CITY OF FRANKLIN
PLAN COMMISSION MEETING*
FRANKLIN CITY HALL COUNCIL CHAMBERS
9229 W. LOOMIS ROAD, FRANKLIN, WISCONSIN
AGENDA
THURSDAY, FEBRUARY 6, 2020, 7:00 P.M.

REPORT TO THE PLAN COMMISSION

Site Plan Amendment

Project Name:	Ballpark Commons Golf Facility, Buildings S2/C3/C4 Site Plan Amendment
Project Address:	7055, 7065, 7075 South Ballpark Drive
Applicant:	BPC Golf Entertainment, LLC Alex Van Osten, representative
Property Owner:	BPC County Land, LLC
Current Zoning:	PDD No. 37
2025 Comprehensive Plan:	Mixed Use
Use of Surrounding Properties:	Golf driving range to the north, South Ballpark Drive to the south, the proposed Indoor Soccer-Baseball facility to the west, and parking areas to the east.
Applicant's Action Requested:	Plan Commission approval of the Site Plan Amendment.

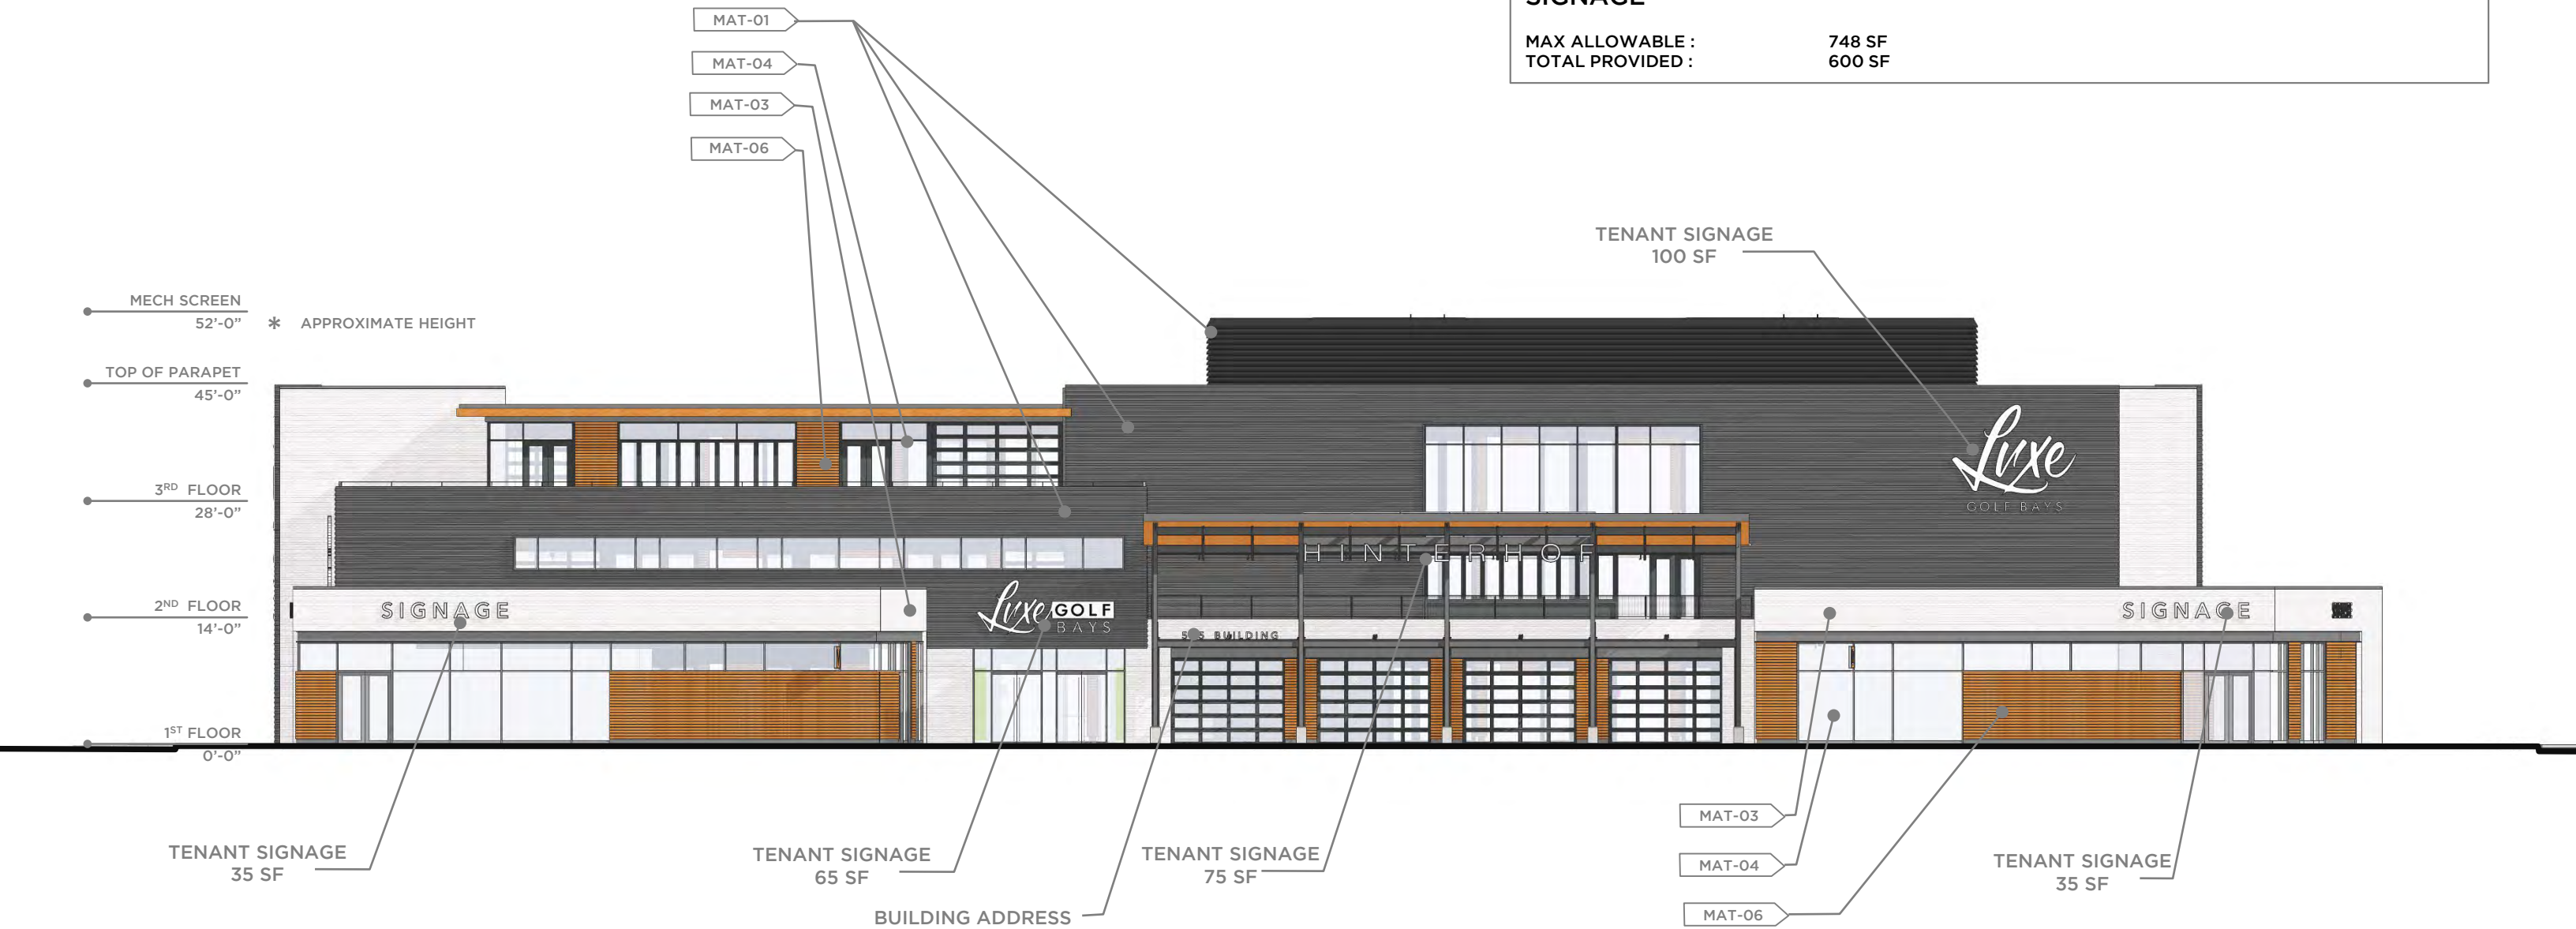
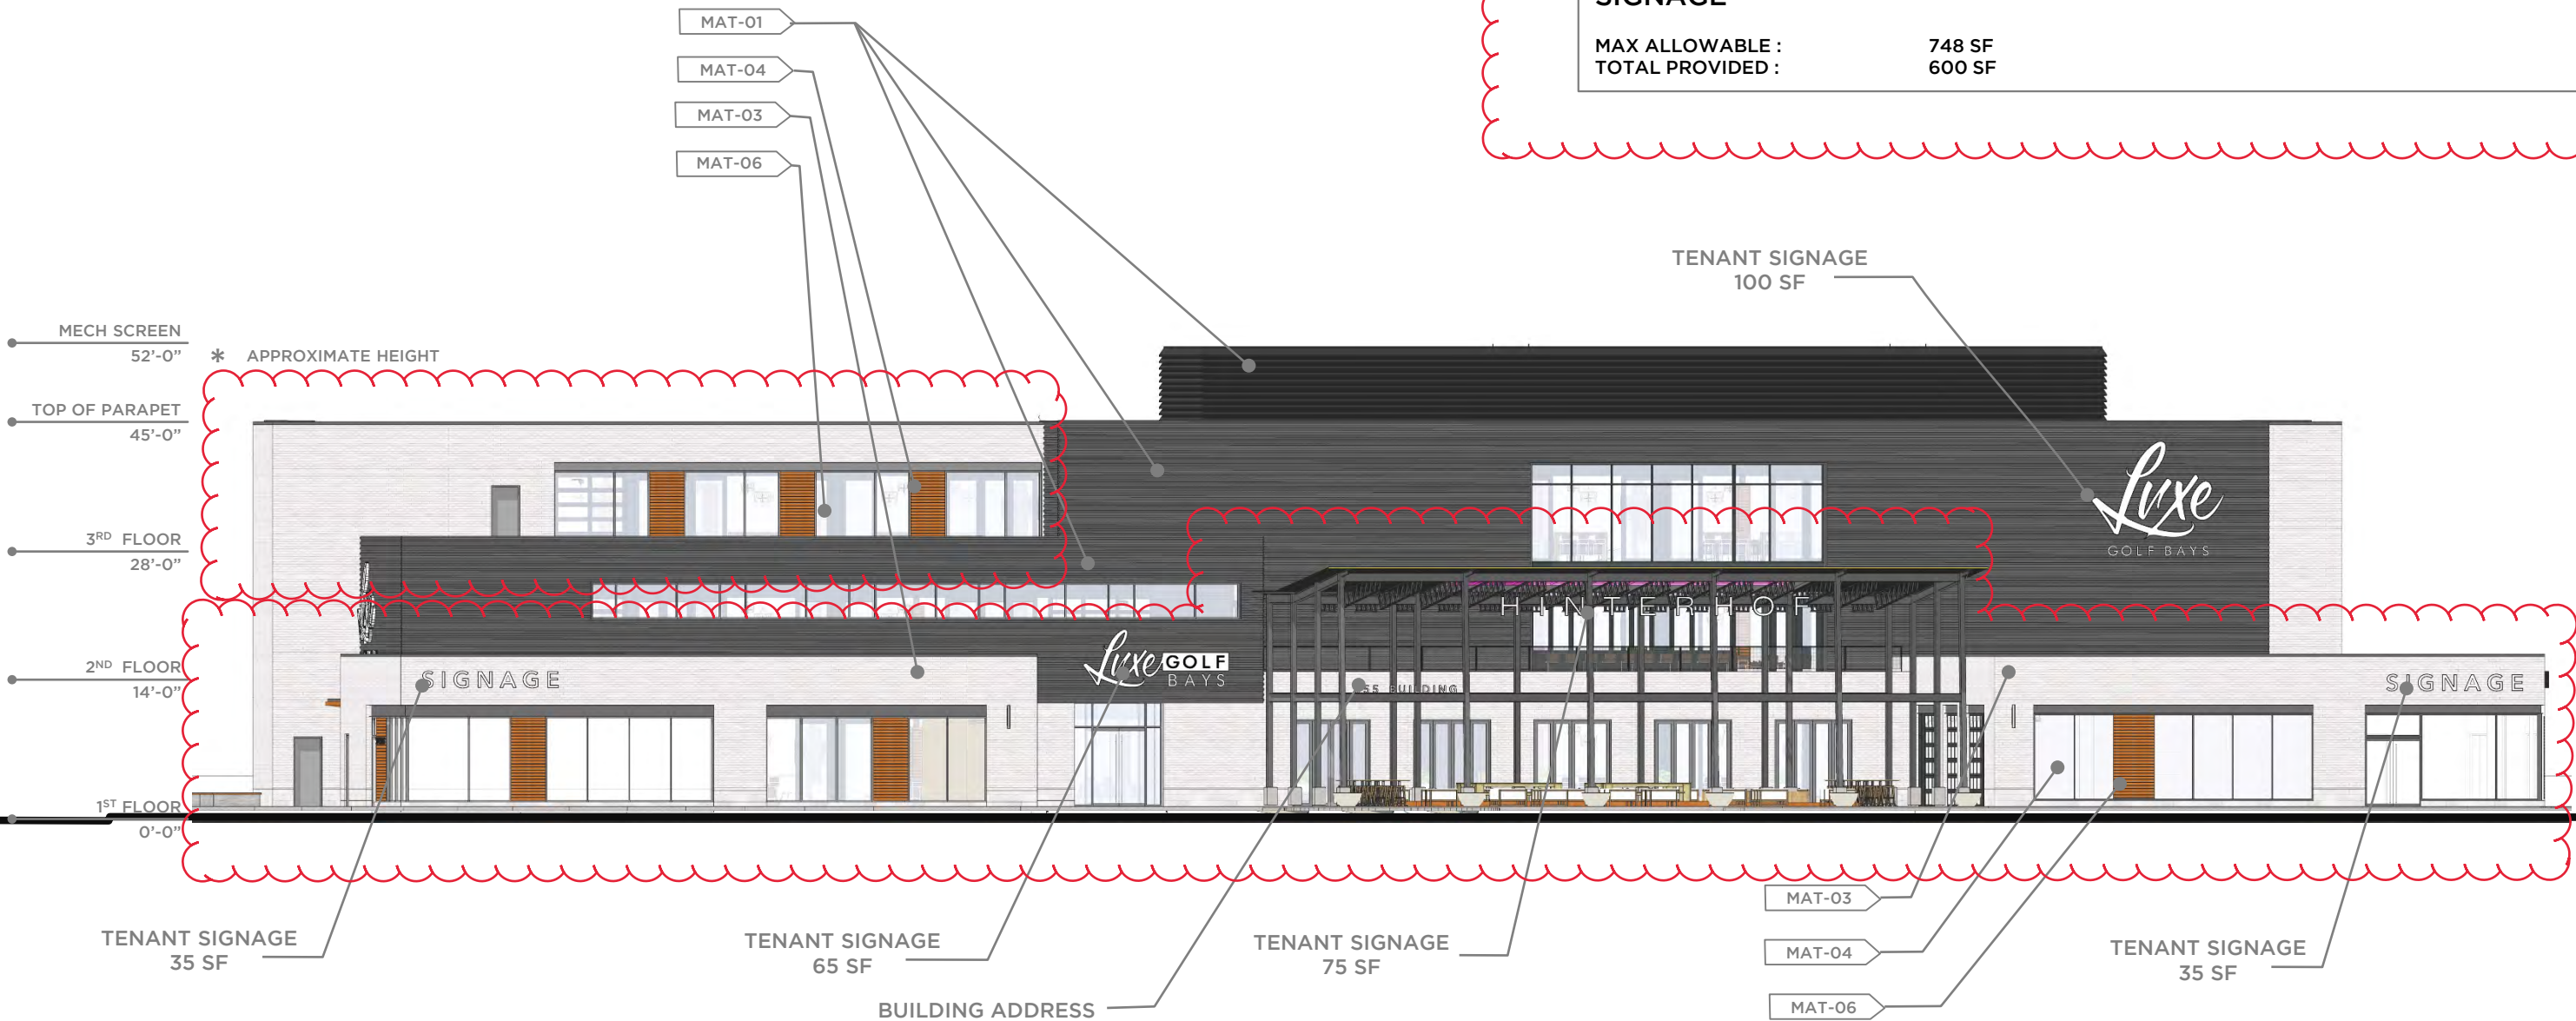
- Much of the longboard aluminum panel siding (wood grain) has been removed from the exterior of the building and replaced with white masonry.
 - Staff comment: This request would reduce the architectural accent provided by the longboard aluminum siding. Even though the proposed brick masonry is a preferred primary material per PDD Section 15-3.0442.E(B)(5)(iii), staff is not recommending approval of this change.

- Staff does not agree with the removal of the longboard – aluminum panel siding (**all elevations**), unless compensating architectural or site enhancements were added. Value engineering. Will discuss this at plan commission.
- Staff does not agree with reduction of the height of the first level (**all elevations**). Please verify and 'bubble' this change. Value engineering. Will discuss this at plan commission.
- Please 'bubble' the decrease in size of the second level on the west side of the building. Value engineering. Will discuss this at plan commission.

- The materials and colors of the Hinterhof ceiling shall be in substantial compliance with the previously approved plans dated April 5, 2018.
- The height of the parapets for the first level shall be in substantial compliance with the previously approved plans dated April 5, 2018.
- This site plan amendment is not approving a reduction of the area covered by the longboard aluminum panel siding (wood grain: light cherry) as architectural accent for the south elevation.

VIEW FROM SOUTH

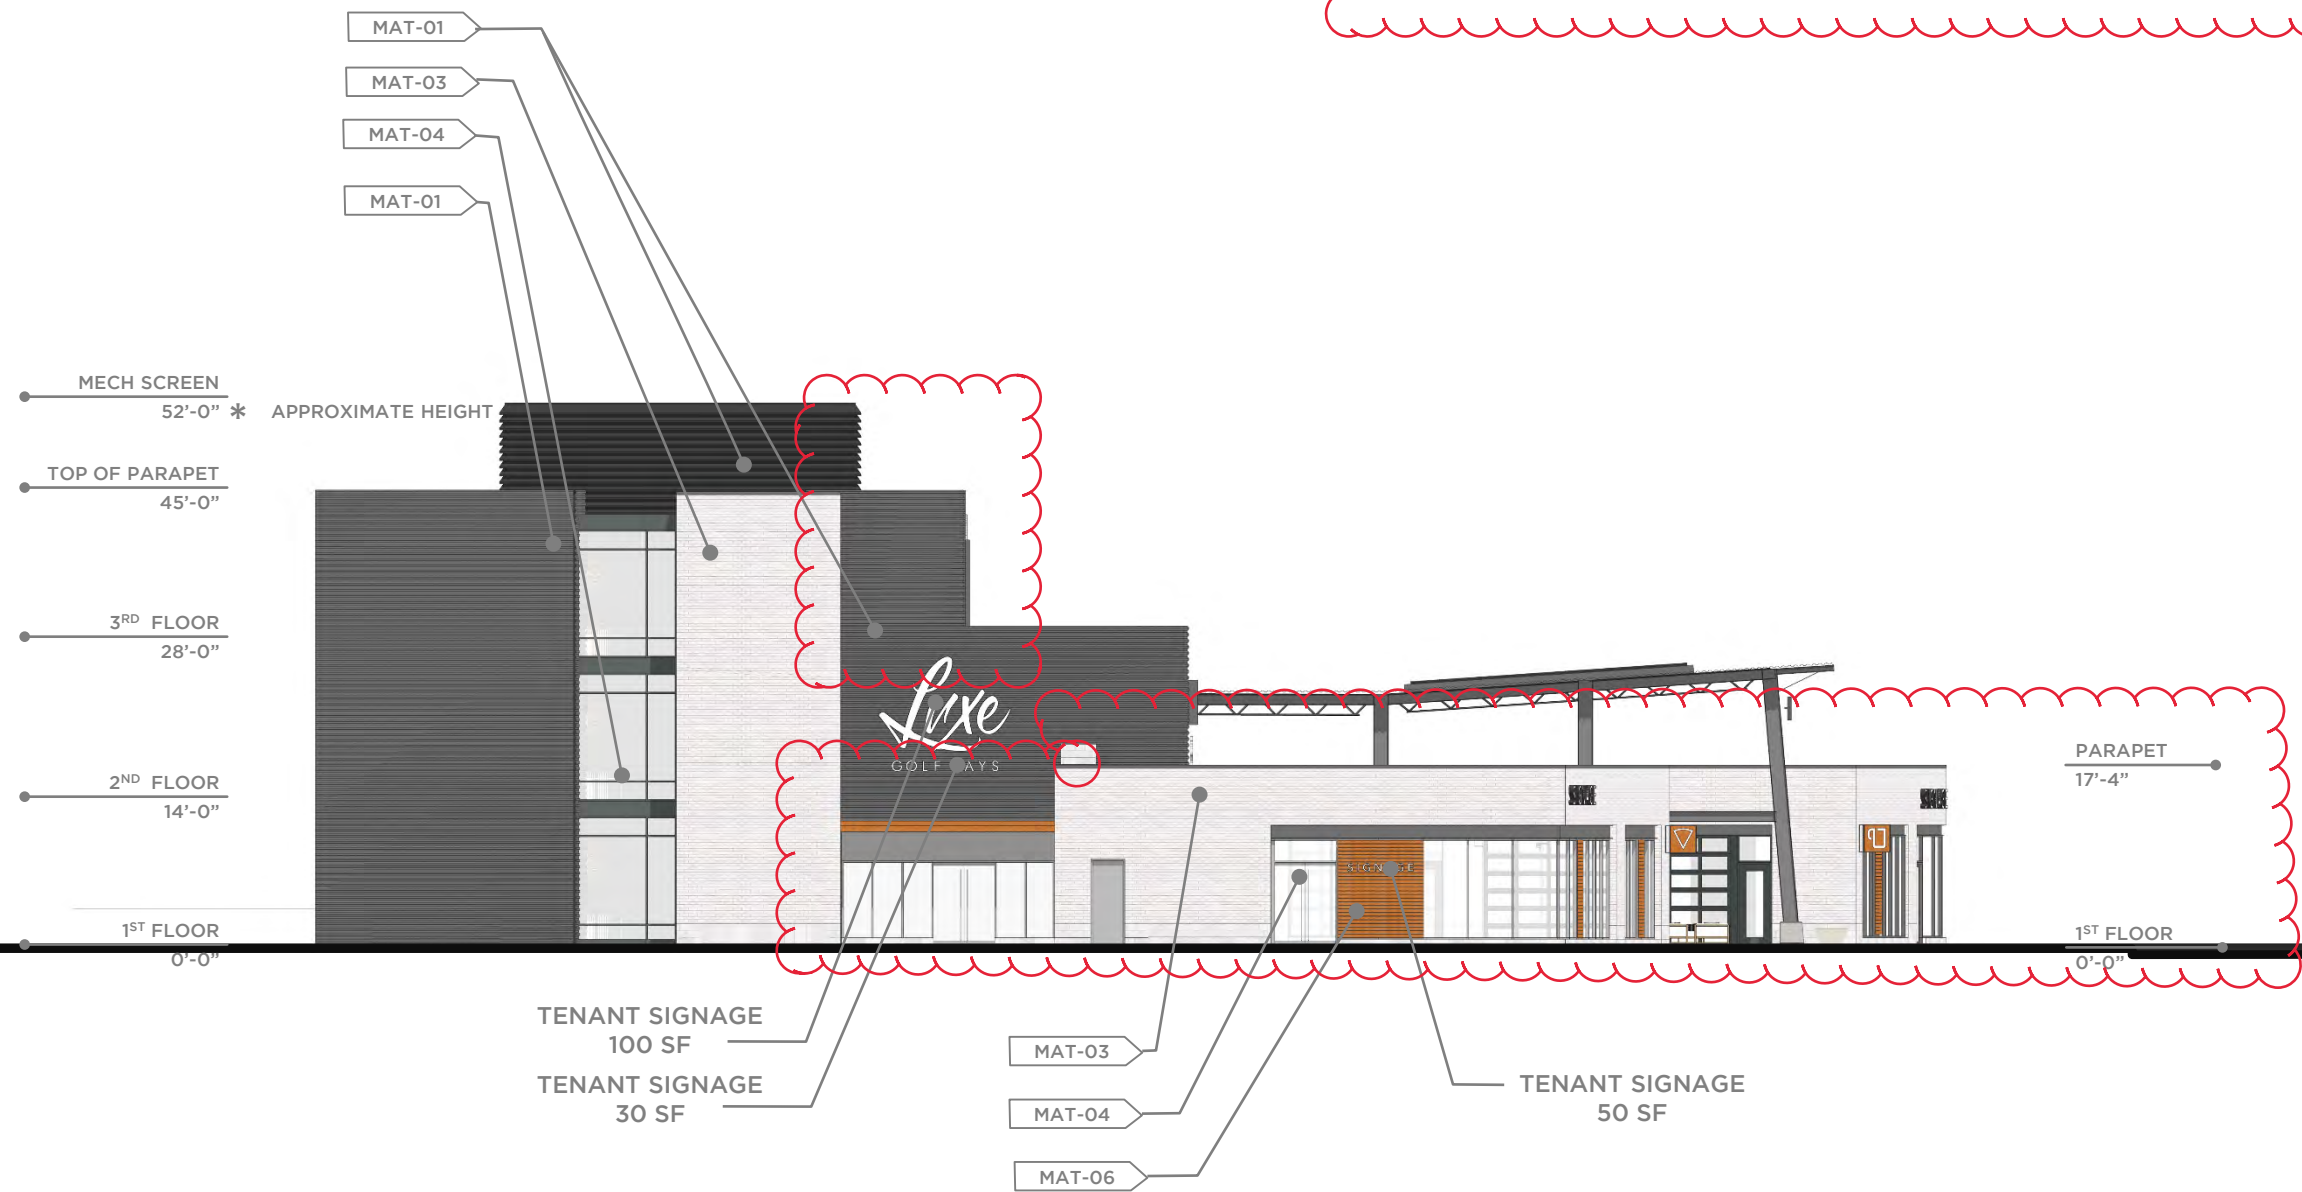
- Staff does not agree with the removal of the longboard – aluminum panel siding from the Hinterhof roof, unless compensating architectural or site enhancements were added. Value engineering. Will discuss this at plan commission.
- Staff does not agree with the removal of the partial glass ceiling under the Hinterhof roof, unless compensating architectural or site enhancements are added. Still have a translucent sky light. Polycarbonate.
